**SAN ANTONIO WATER SYSTEM  
BASIN PUMP STATION IMPROVEMENTS PROJECT  
PHASE 1  
SAWS Job No. 12-6001  
Solicitation No. B-13-017-DD**

**ADDENDUM NO. 1**

**April 19, 2013**

**Consulting Engineer: CP&Y, Inc.**

BASIN PUMP STATION IMPROVEMENTS PROJECT PHASE I  
PROPOSED ONE-LINE DIAGRAM-1

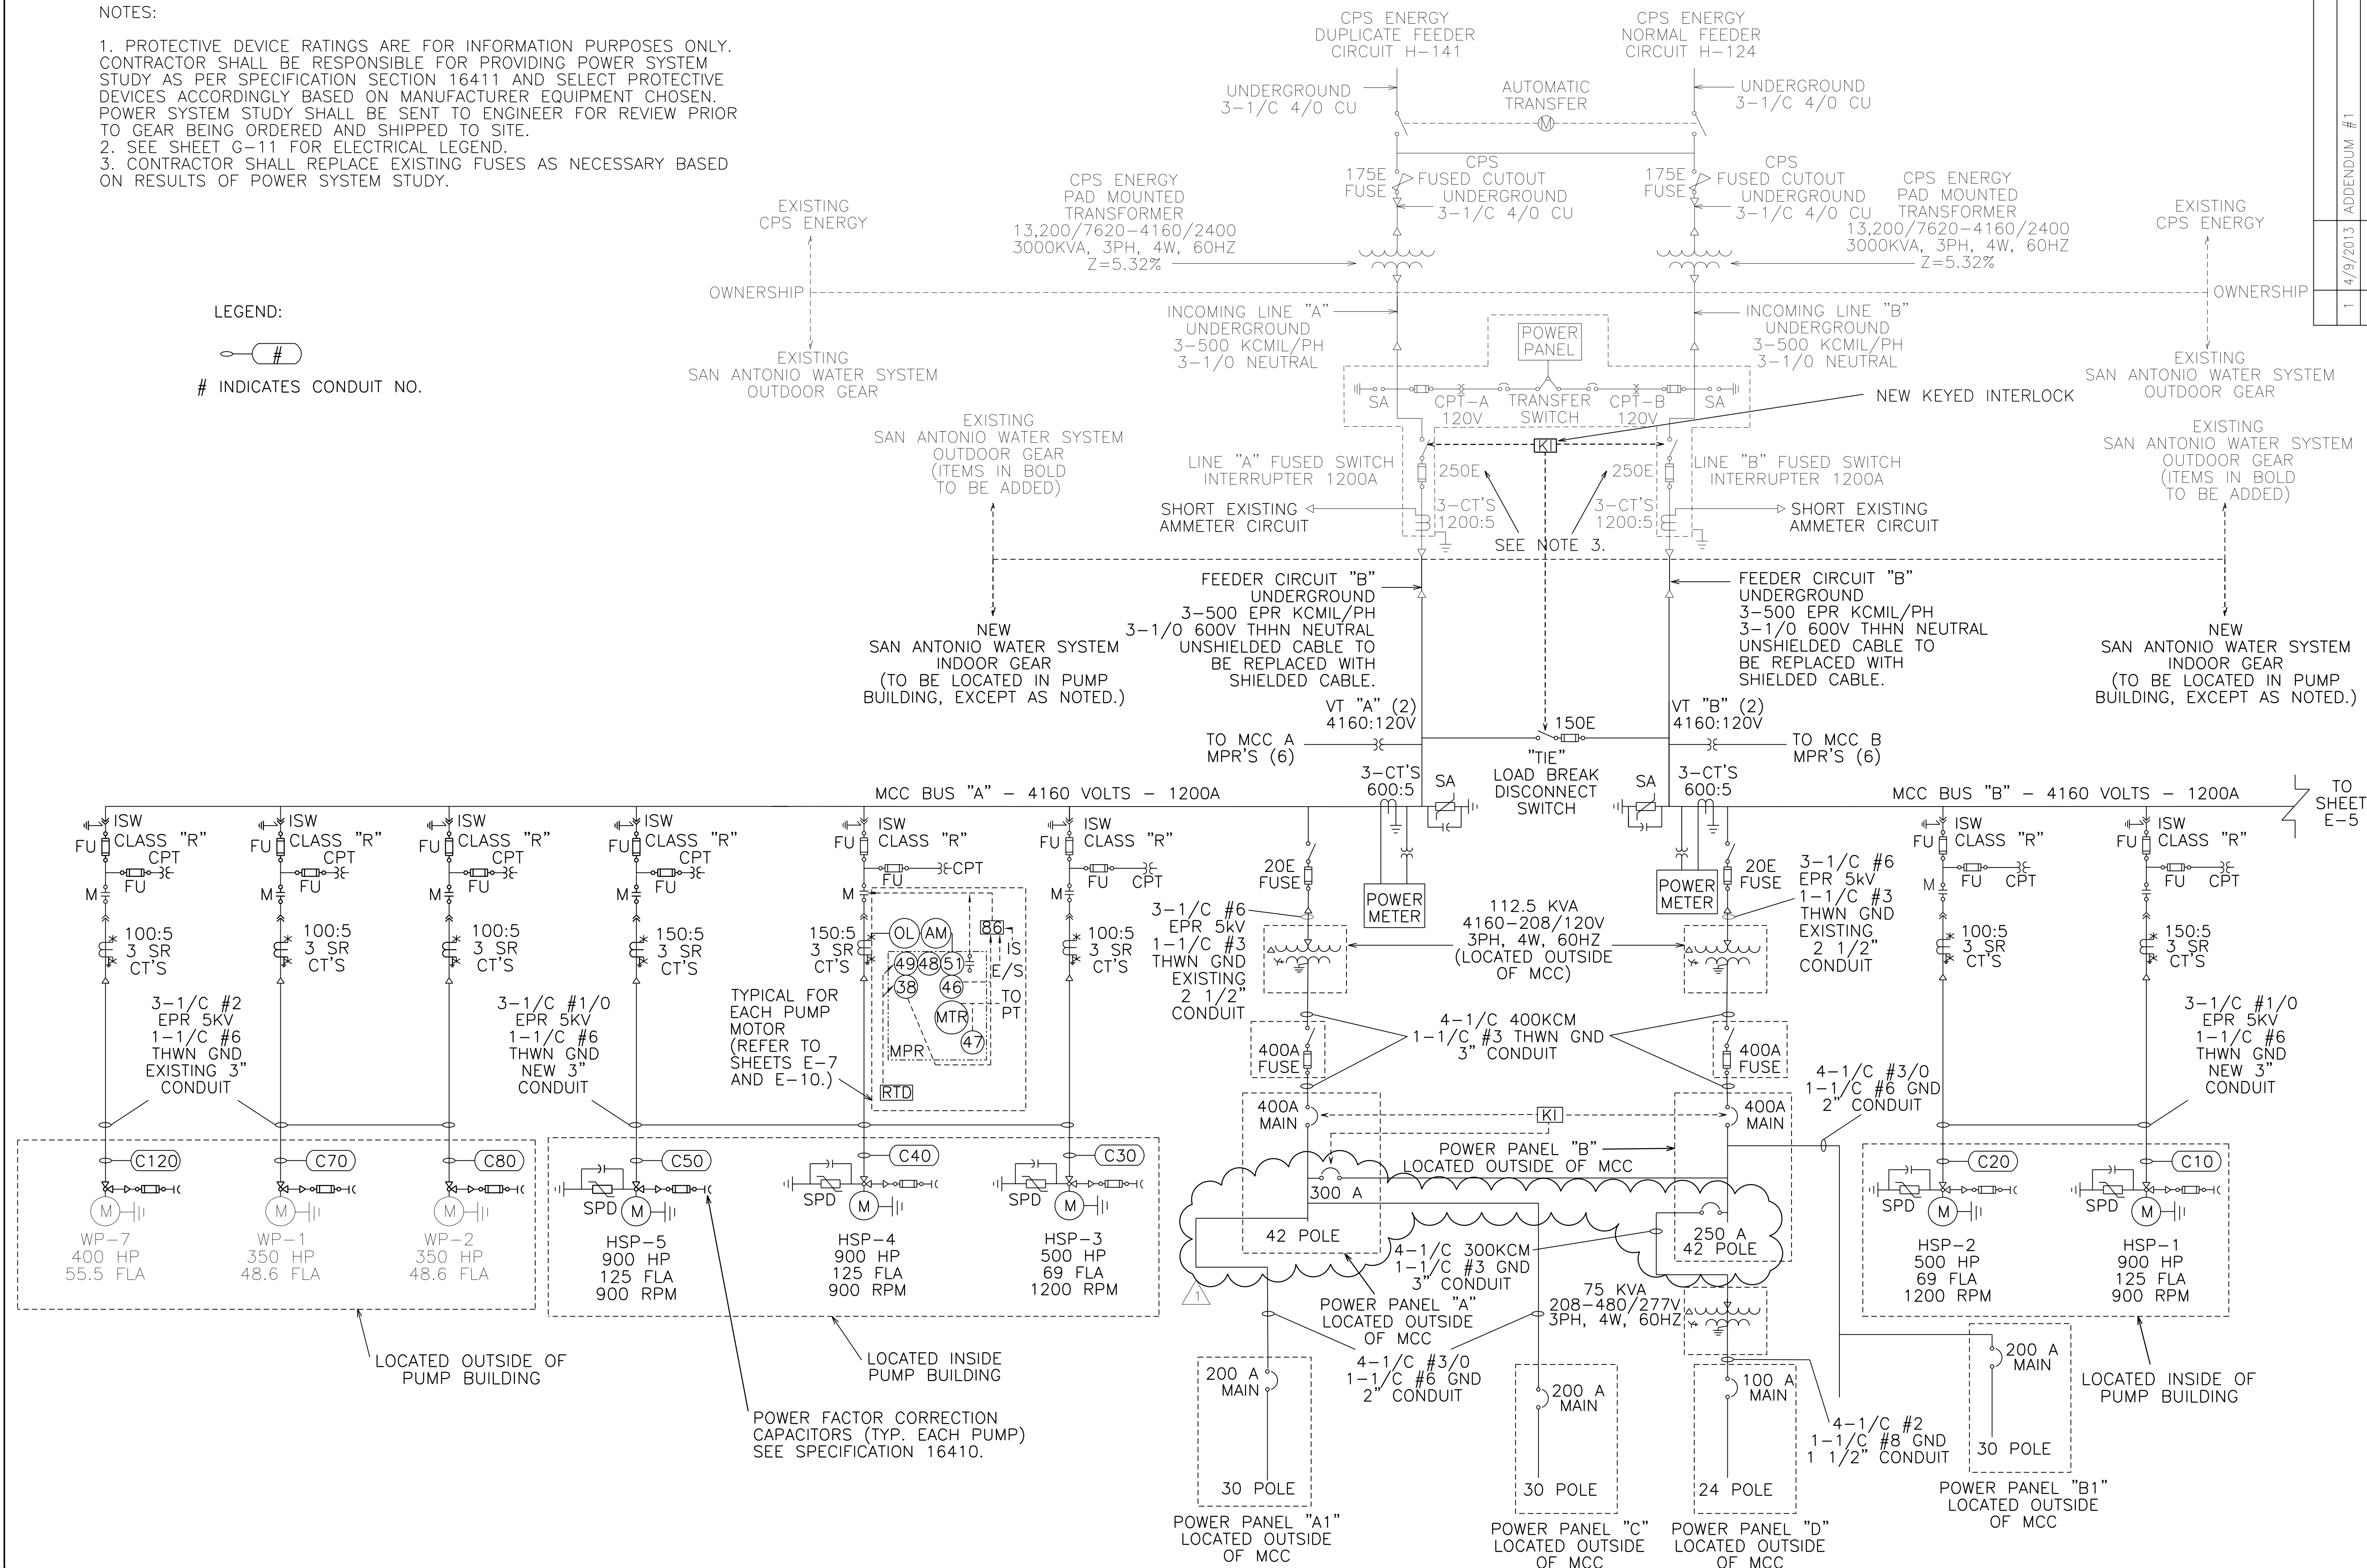
4. Question: Drawing E-4 shows Paneboard 'A' with a 300A Tie Breaker, but on Drawing E-46 Power Panel 'A' Schedule does not show this 300A Breaker. Should the 300A Tie Break be increased to 400A to be in line with the other mains?

- a. Delete this drawing in its entirety and replace with the attached drawing E-4.

Response: No change is warranted. Leave as shown.

**A** POWER PANEL 'C'  
SCALE: NTS

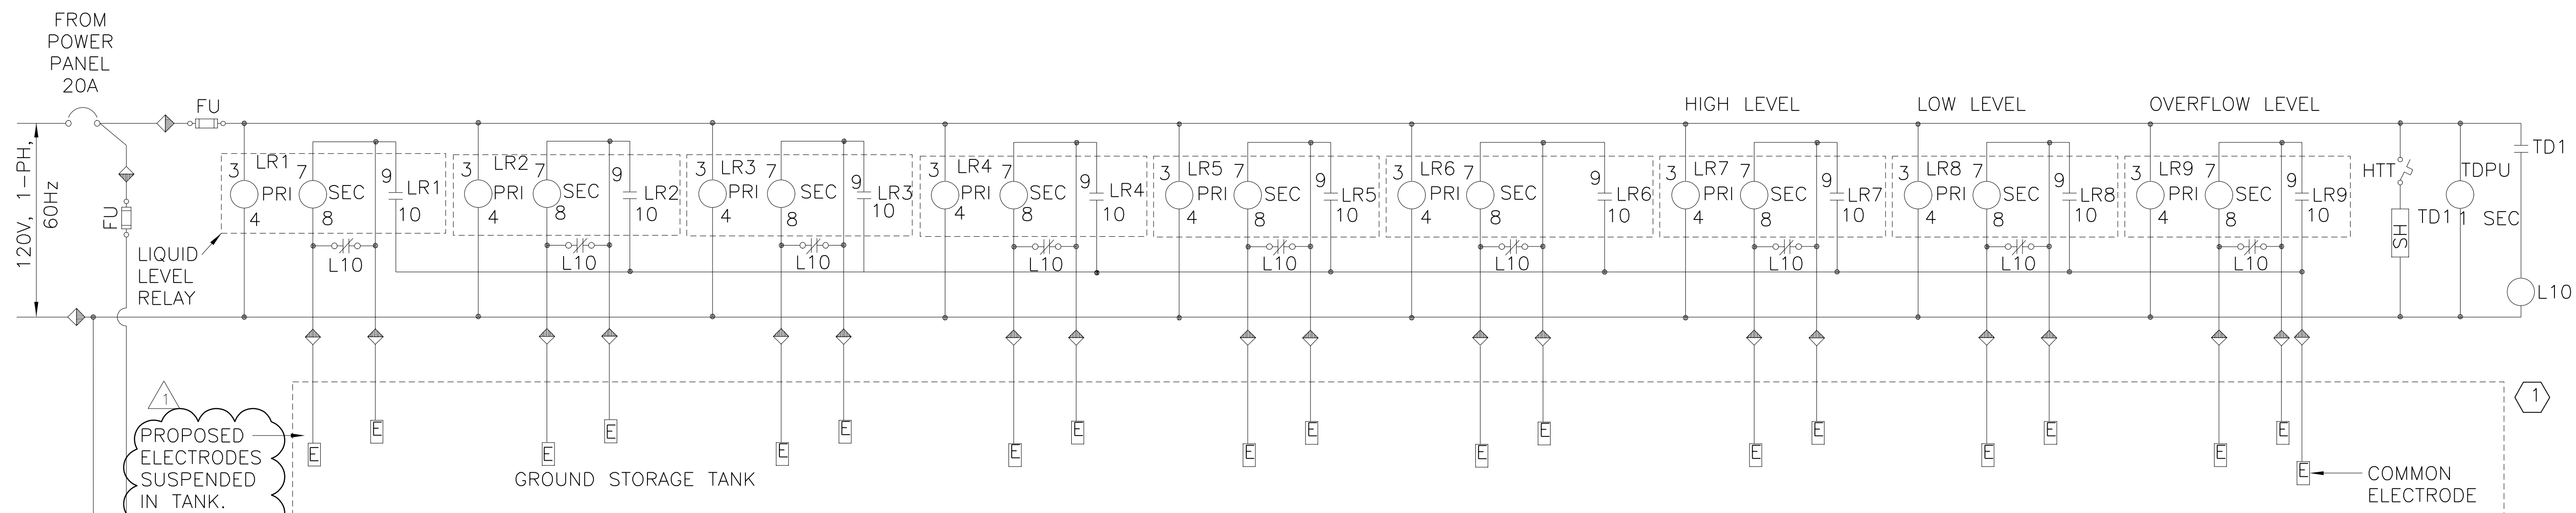
5. Question: Drawing E-48 POWER PANEL 'C' has a 200A Main Breaker, but shows a Future 250A Feeder which exceeds the Main Breaker Ampacity main breaker should be larger than the feeder breaker?

a. Delete this drawing in its entirety and replace with the attached drawing E-48.

Response: The feeder breaker has been deleted. Refer to attached Drawing E-48.
